## DECISION OF 3700<sup>th</sup> COUNCIL MEETING HELD ON 19 FEBRUARY 2018

### 9. **CiS04: Planning Proposal 4/17 – 41 McLaren Street, North Sydney**

**SUBJECT:** Planning Proposal 4/17 – 41 McLaren Street, North Sydney**AUTHOR:** Ben Boyd, Executive Strategic Planner**ENDORSED BY:** Joseph Hill, Director City Strategy**EXECUTIVE SUMMARY:**

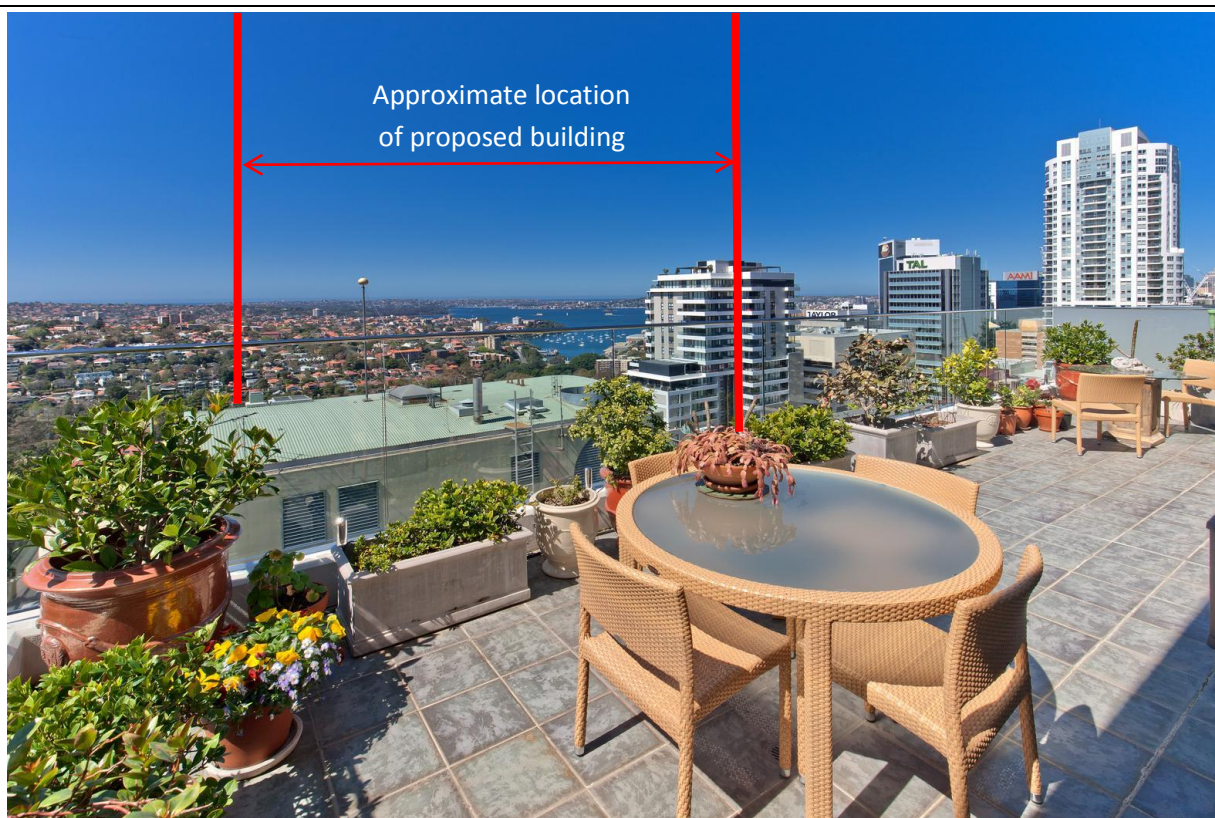
It is noted that the applicant of the Planning Proposal specifically objected to the proposed height controls for the subject site under the draft WSP Masterplan. The applicant's alternative solutions are replicated in the accompanying documentation to the Planning Proposal.

*Ultimately, a balance of economic viability in building forms and protection of surrounds must be struck through a design-led process.*

*Action – Pursue further design refinement to ensure the Masterplan is envisaging commercially attractive envelopes that appropriately manage surrounding amenity.*

#### FIGURE 12: Visual impact

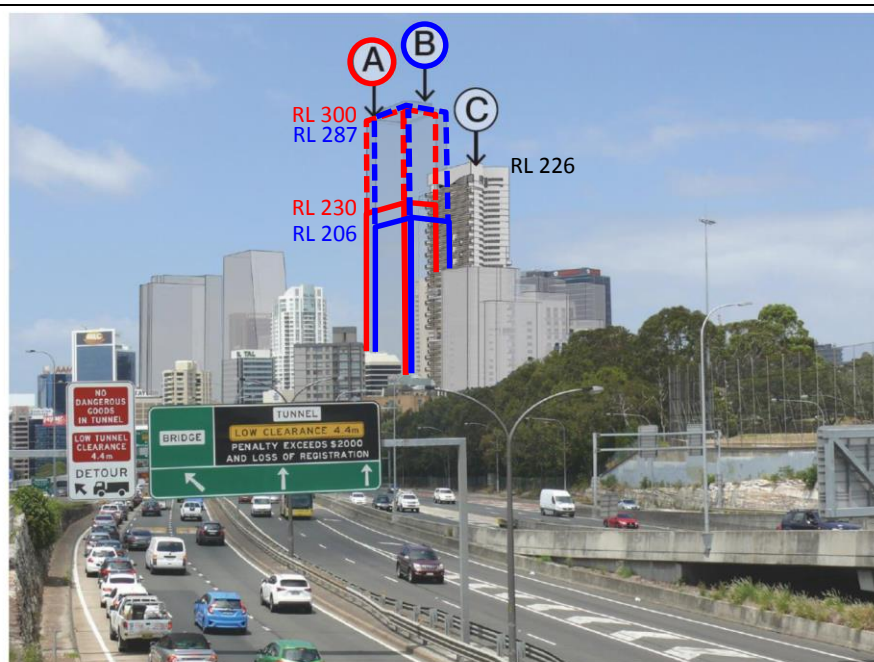
The Planning Proposal includes an assessment of the potential visual impact of a building on the subject site consistent with the proposed height. This assessment was made within the context of future development within the Ward Street Precinct as suggested under the applicant's "Alternative Masterplan" for the Precinct. Given that the Masterplan is currently being reviewed and refined, there is no guarantee that the applicant's "Alternative Masterplan" will be pursued. Furthermore, the assessment assumes that the over station development site on Miller Street will accommodate a 60 storey commercial tower (to RL 300m), when in reality it will be closer to 40 storeys at RL 230m which is consistent with the outcomes of the North Sydney Centre Review and the concept proposal issued by Transport for NSW with respect to obtaining the Secretary's Environmental Assessment Requirements for the over-station development. This is a significant misrepresentation of the future context of the North Sydney skyline.

Building heights should generally be highest within the geographical middle of commercial centres and taper down towards its edges. The proposed height over the subject site is too high, given the Metro Station site would approximately represent the geographical middle of the Centre (the corner of Berry and Miller Streets) and presently it is proposed to accommodate a tower to RL 230m. FIGURE 12 represents the degree of contextual misrepresentation that the applicant has provided and indicates that the height proposal would be out of context with the remainder of development within the North Sydney Centre.

**Figure 13 – Separation impacts upon adjoining sites**

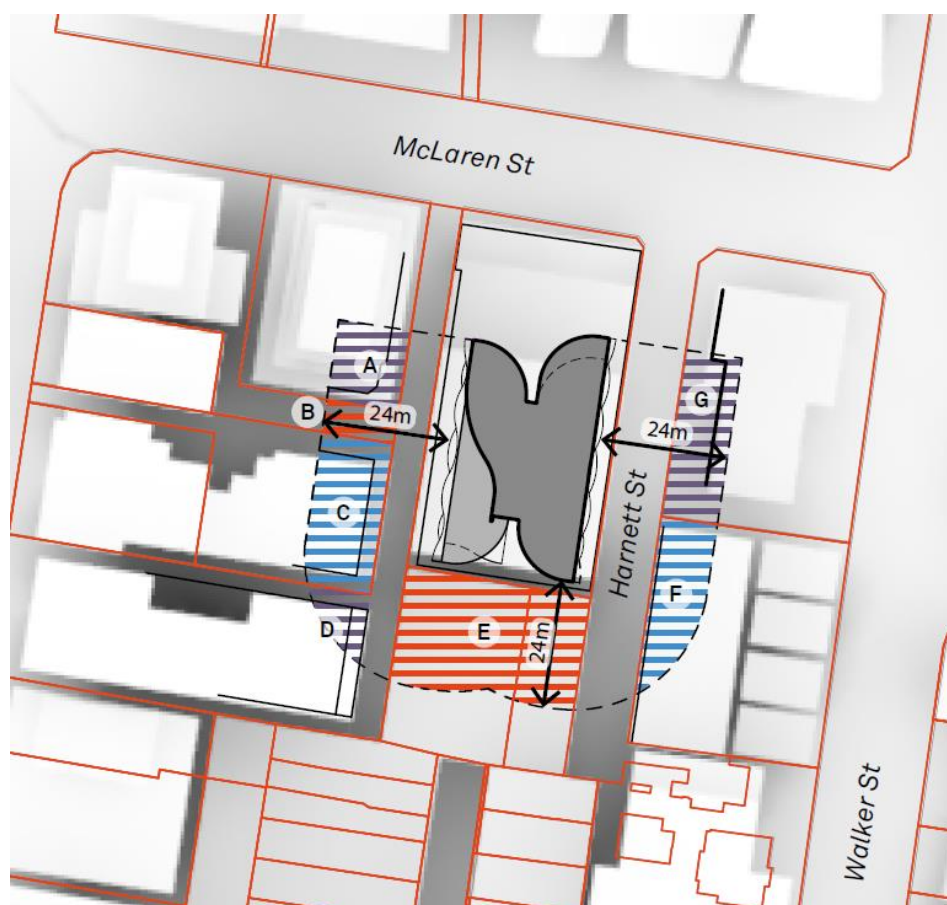
*Furthermore, the non-compliant separation proposed between residential apartments at 41 McLaren street unfairly restrict redevelopment on adjacent sites by pushing the burden for providing compliant separation onto 144-150 McLaren St [Walker Street], 45 McLaren St and Council's Ward Street Carpark Site (see Figure 13 below).*

This further demonstrates that the proposal should not proceed at this point in time.
